ERRATA

TO THE TSB12C01A 1394 LINK LAYER CONTROLLER DATA MANUAL

(TEXAS INSTRUMENTS LITERATURE NO. SLLS219A, FEBRUARY 1997)

Figure 4–Y. Receive Self-ID Format

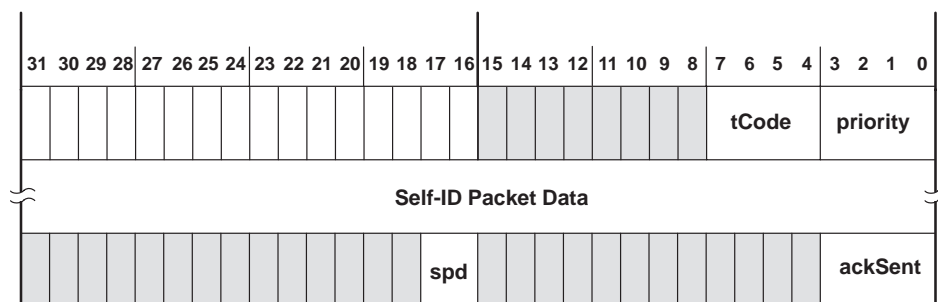
bb. Replace the *Receive Self-ID* paragraph, figure, and table where indicated in the specified documents, with the following paragraph, figure, and table.

4–X Receive Self-ID

The format of the receive Self-ID packet is shown in Figure 4–Y. The first quadlet is the packet header with the special tCode of Eh. The quadlets that follow are a concatenation of all the received Self-ID packets, followed by the final packet status quadlet.

Table 4–Z. Receive Self-ID Functions

FIELD NAME	DESCRIPTION
tCode	This field carries the special transaction code of 1110b.
priority	This field carries the priority level for this packet.
Self-ID packet data	This field contains a concatenation of all the Self-ID packets received.
spd	This field indicates the speed at which this packet was sent. All Self-ID packets are sent at the base rate of 100 Mbps. spd = 00 for 100 Mbps
ackSent	This field holds the acknowledge sent by the receiver for this packet.
